To: T10 Technical Committee  
From: Ed D'Avignon, Vitesse Semiconductor (davignon@vitesse.com)  
Date: 27 April 2006  
Subject: 06-212r0 SAS-2 Zone Group of an Expander's SMP

**Figure 1 — ZPSDS attached to SAS-1/SAS-1.1 expanders outside the ZPSDS**

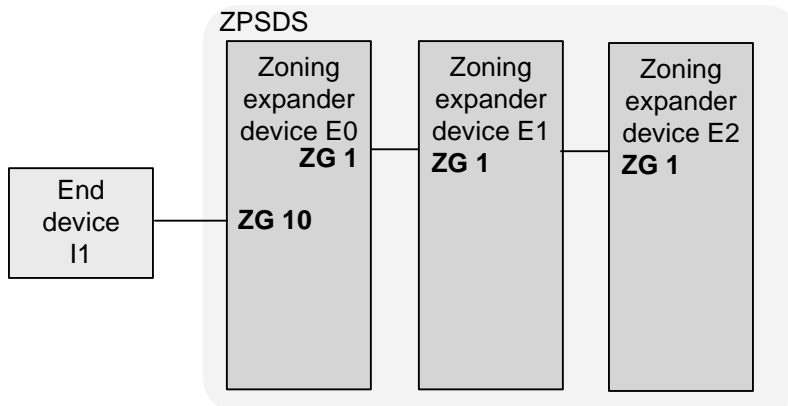
In Figure 1, End device I1 is able to route to send an open to the SMP target in Expanders E0, E1 and E2 because:

- a) above causes an open to E1 to have a destination group of 1 because the participating phy on E0 is in group 1.
- b) above causes an open to E0 to have a destination Group of 1
- c) above causes an open to E2 to have a destination group of 1 when the destination is looked up in the zoning route table of E0

The SMP in all of the expanders can send an SMP request to I1 because d) above requires the source group in the OPEN frame built by the SMP be set to 1.
